Briefing Note

Our ref 64194/06/MS/OW
Date 16 April 2025
To Planning Inspectorate
From Oxford Aviation Services Limited

Subject Open Floor Hearing – Written Submission on behalf of Oxford Aviation Services Limited (London Oxford Airport)

Review of Engine Failure After Take-off
options for
Botley West Solar Farm Proposal

EFATO Zones

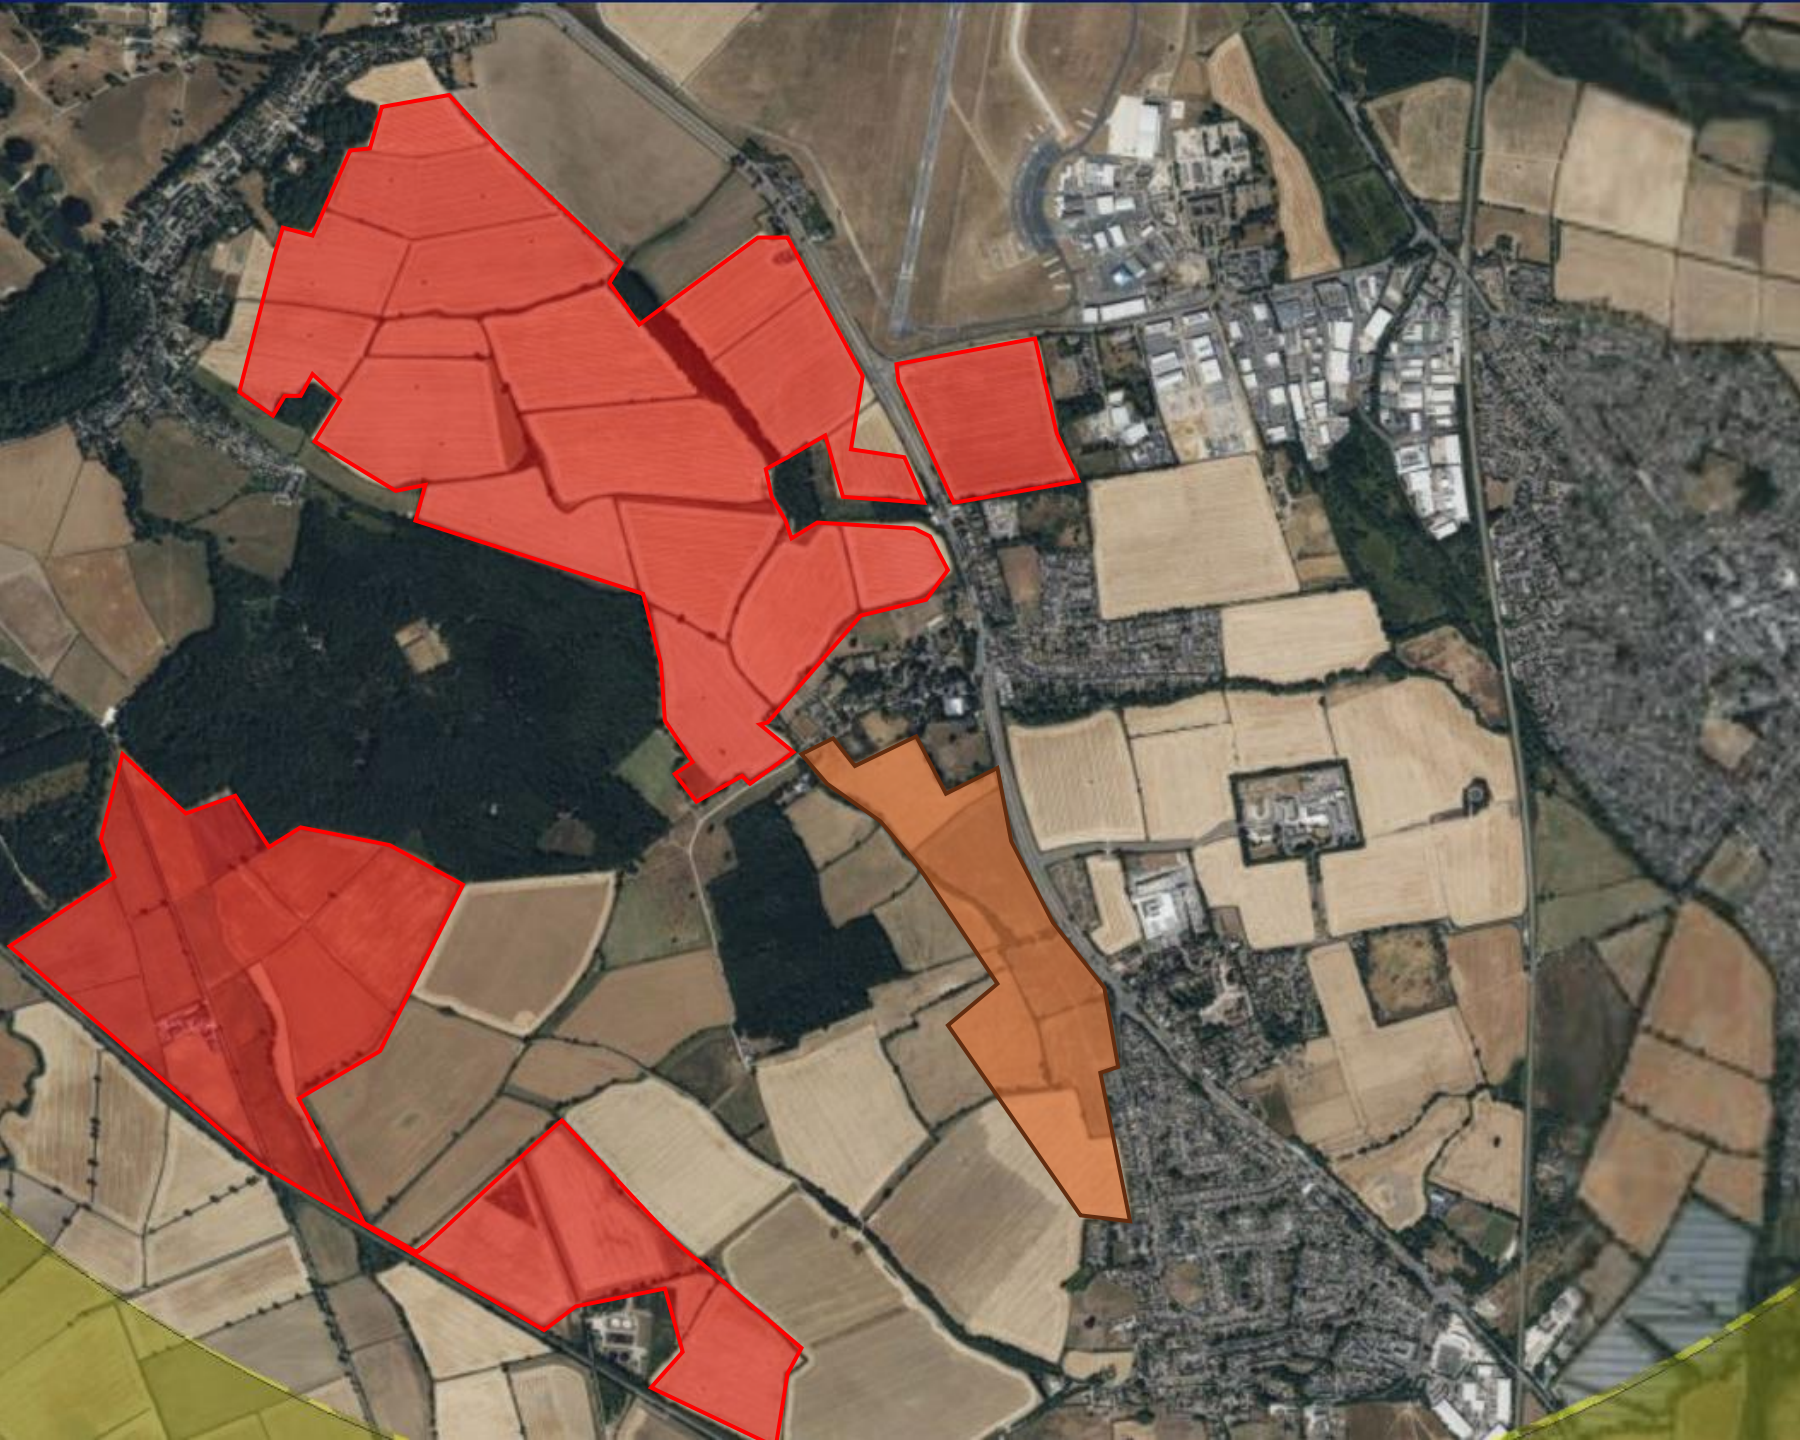
The Local Runway Safety Team (LRST), which includes the based flight training schools, has determined that the areas identified here are the areas most likely to be required in the event of an EFATO event.

It is not possible to define specific fields as every event is different based on the height of the aircraft above the ground at the point of engine failure and also environmental factors such as wind speed and direction.

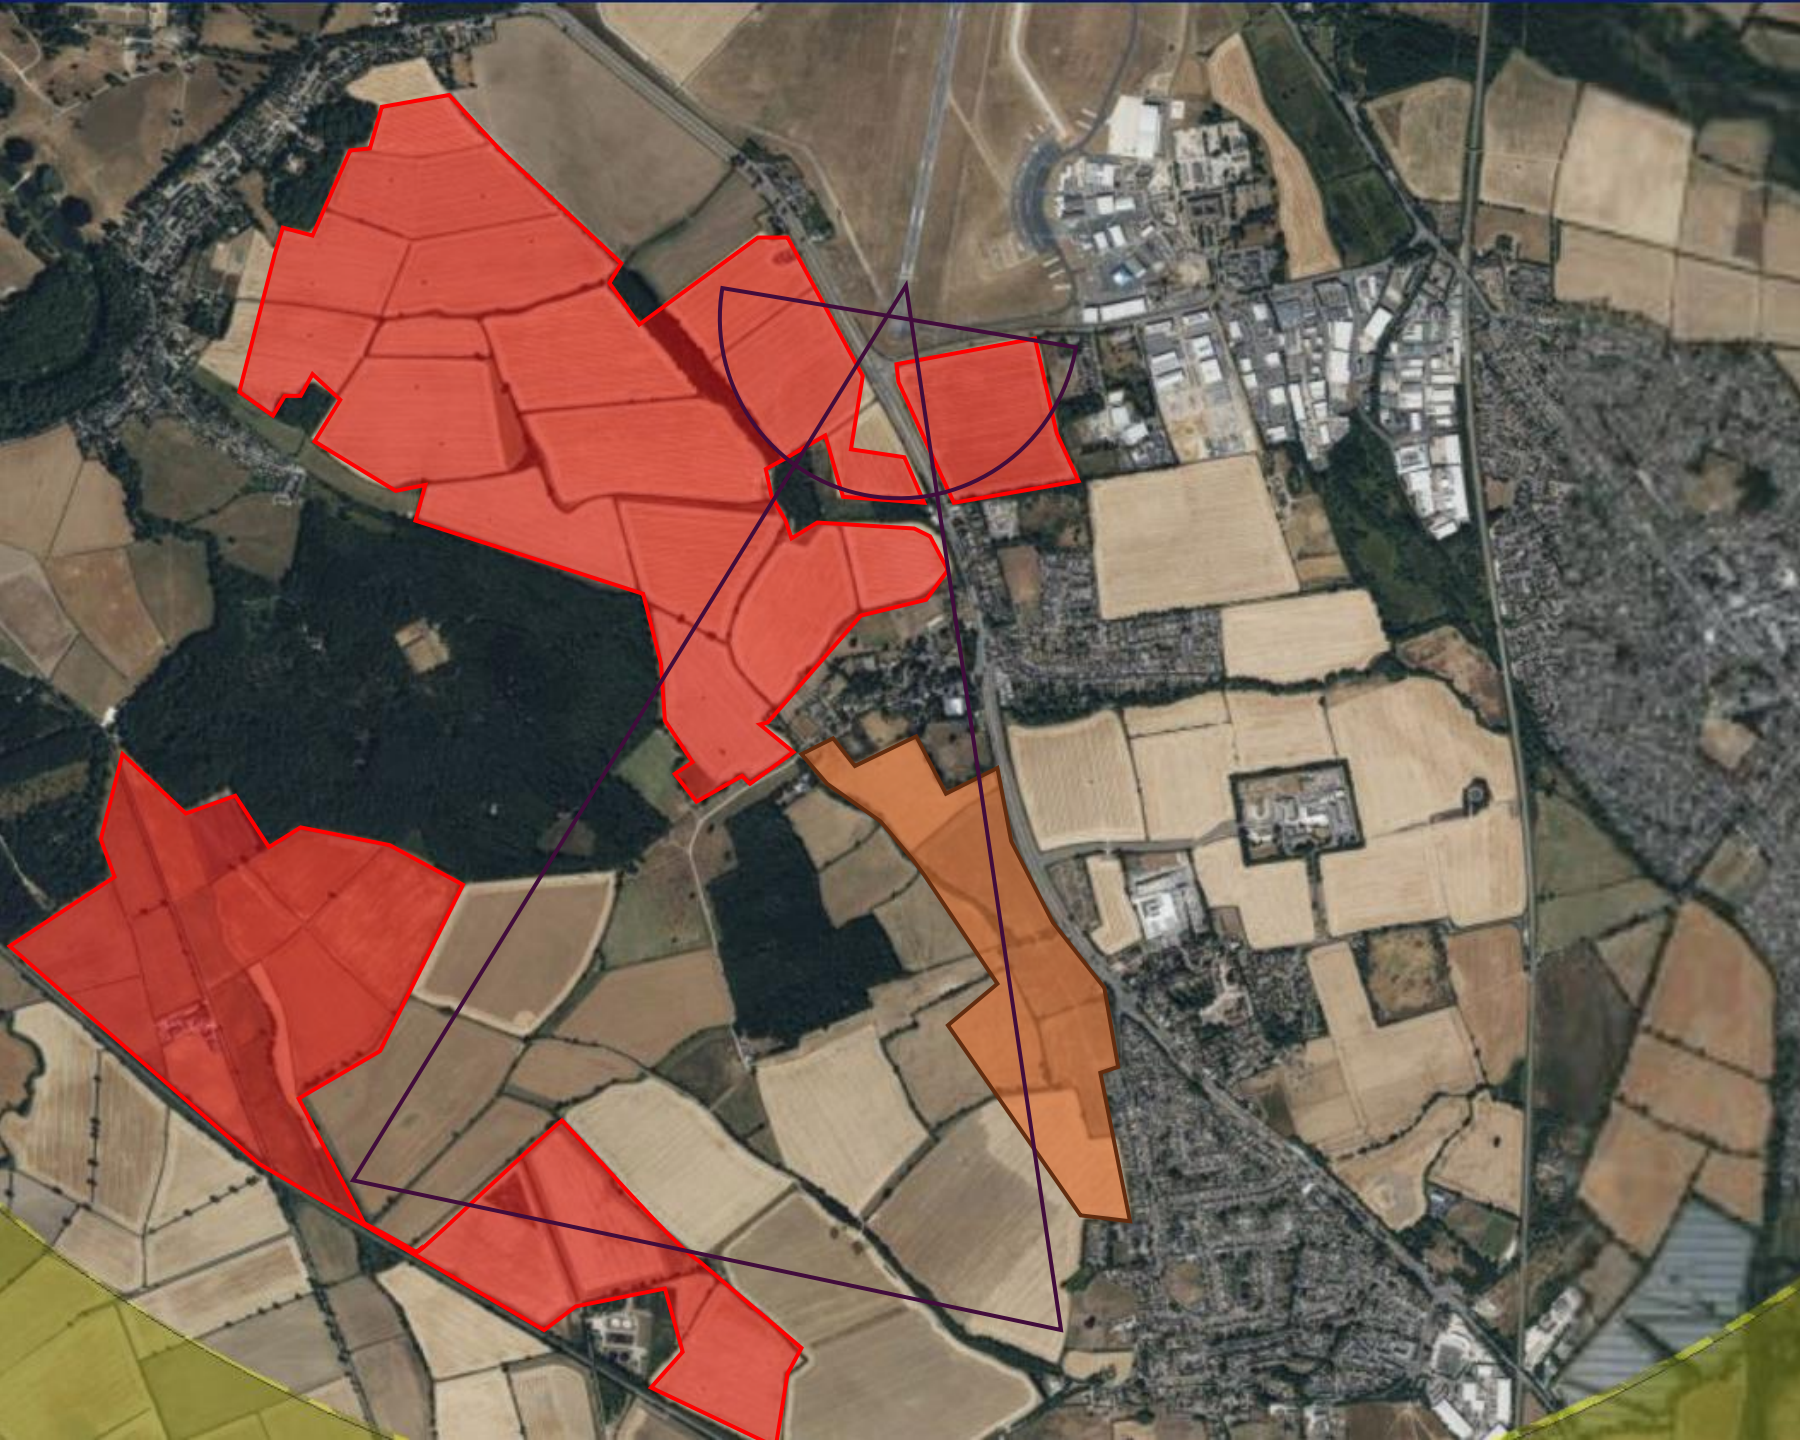
This image shows in red the areas where it is proposed to install solar panels (as shown in drawing 2.4 Land Plans from the DCO application).

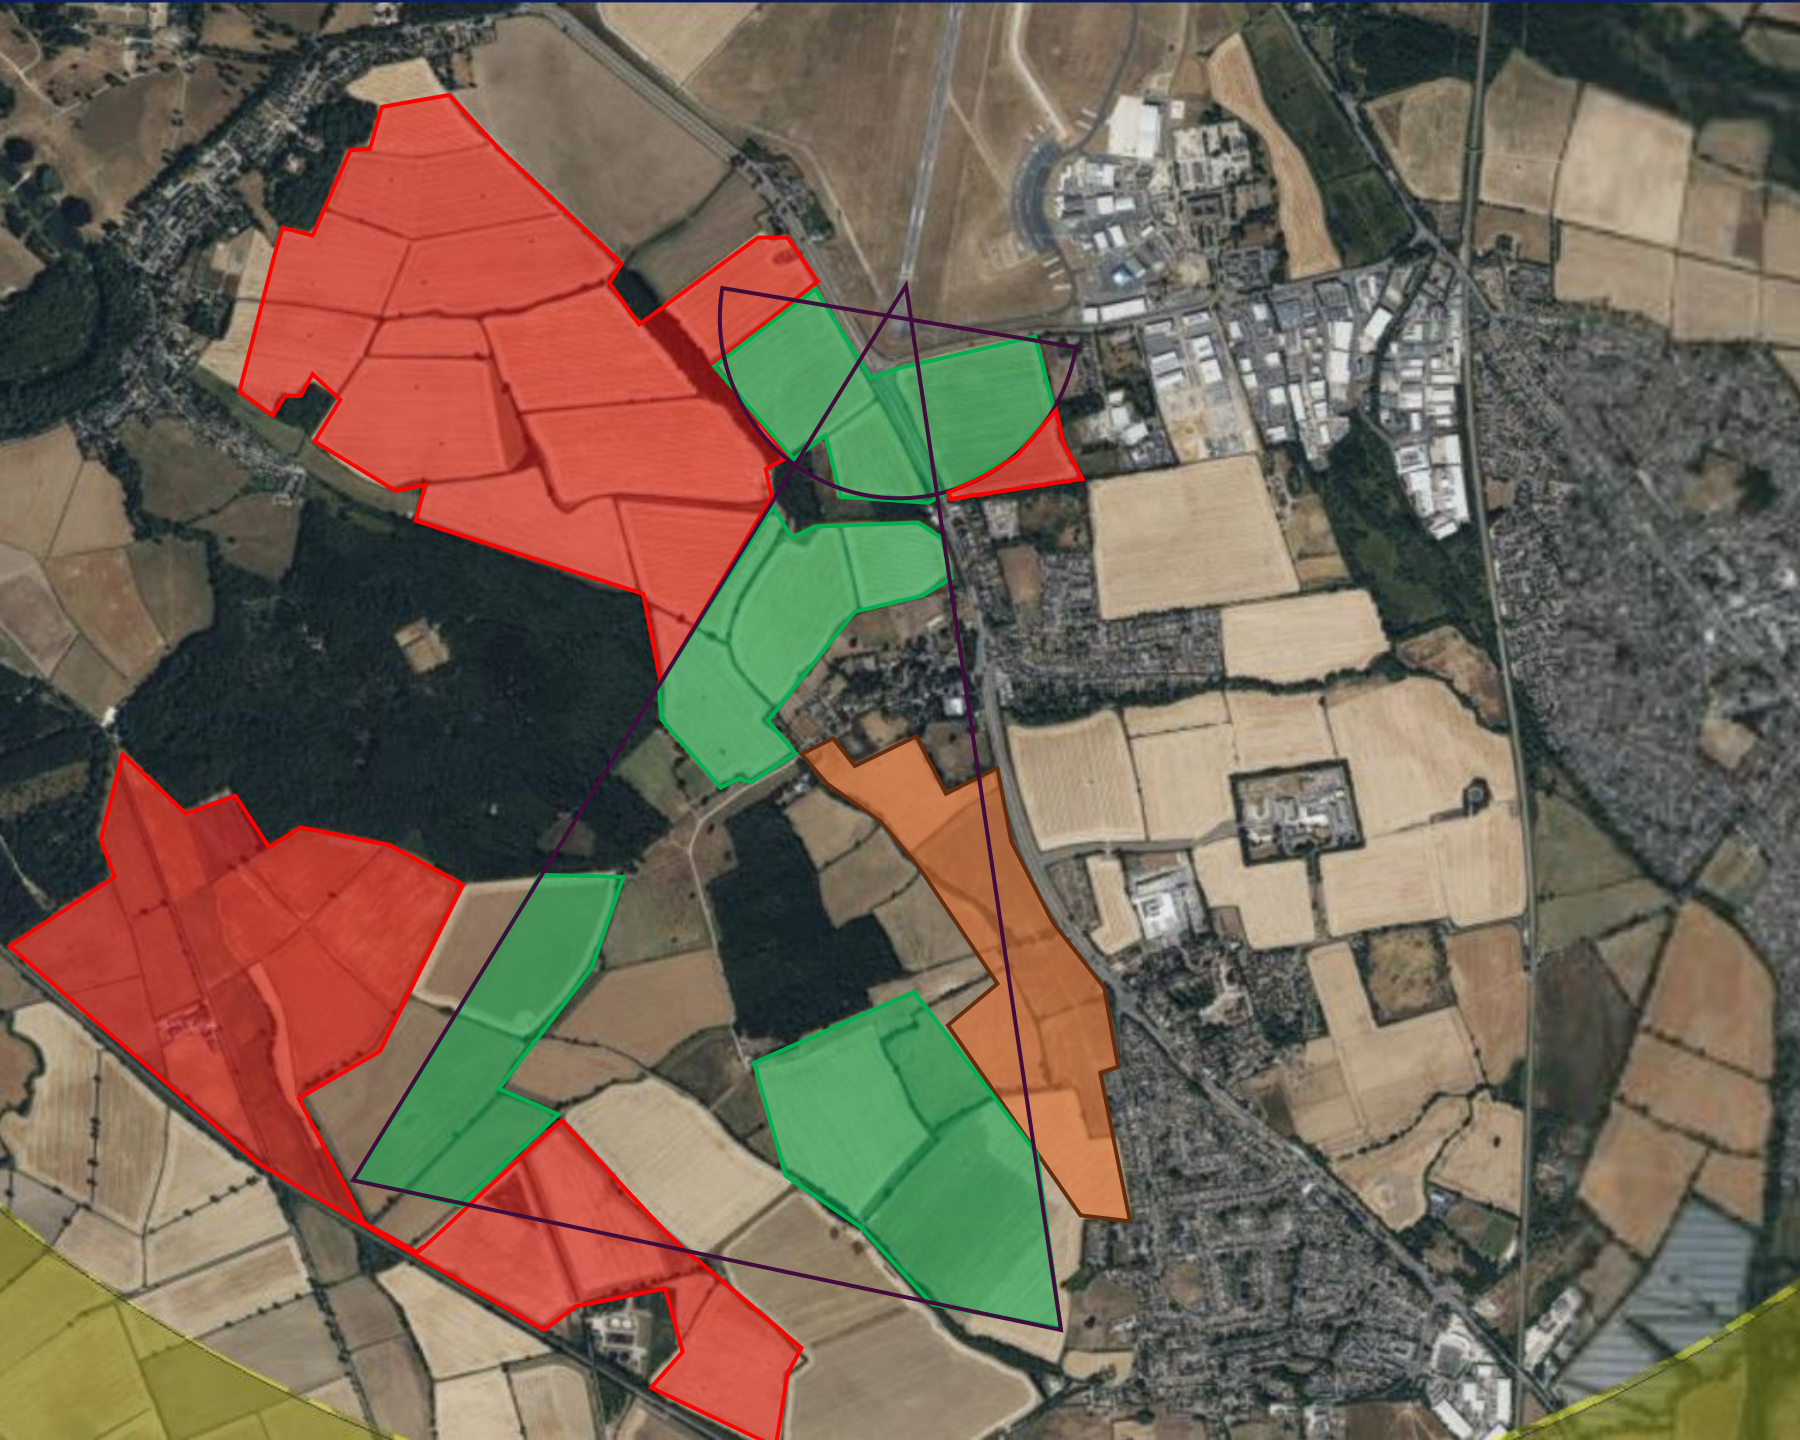
This image shows the areas within the designated EFATO zones that would be unavailable for use in the event of an EFATO if the proposals were to be permitted.

As an absolute minimum the LRST recommend that the areas shown in green are protected from future development to safeguard the future of single engine flight training at London Oxford Airport.

Fig. 1 – extracted plan showing habitat creation in close proximity to the airport

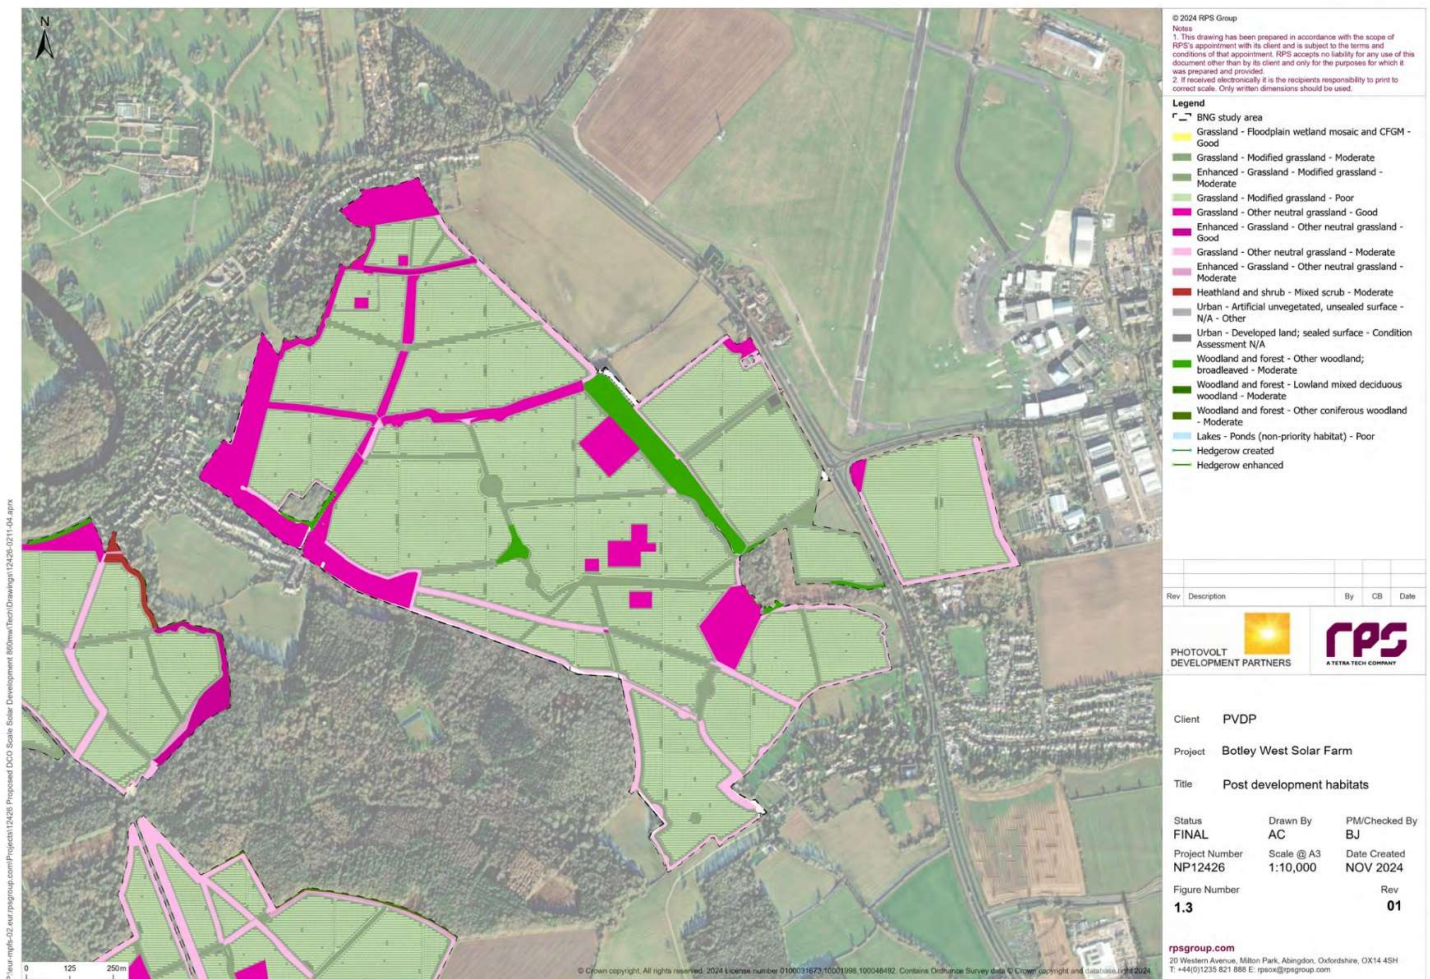
- 3.1. As set out in the Biodiversity Net Gain report¹ for the site a large extent of grassland, woodland and hedgerow is to be created across the development site, including in close proximity to the airport. In addition, extensive swathes of agricultural land are to be replaced with photovoltaic (PV) arrays. This is illustrated in Figure 1 below which presents an excerpt of the plans showing the proposed vegetation post-development in the areas closest to the airport.

- 3.6. **Re-distribution.** In addition to the habitats which are to be lost or degraded as a result of the installation of the PV panels, areas of habitat are to be enhanced around the periphery of the development site. As illustrated in Figure 1 above this includes areas of species-rich grassland adjacent to the airport's boundary. These have been designed to attract birds, with the ES stating that "wildflower meadow grasslands will be managed specifically for wintering birds including wintering seed mixes to provide foraging resources for wintering birds."
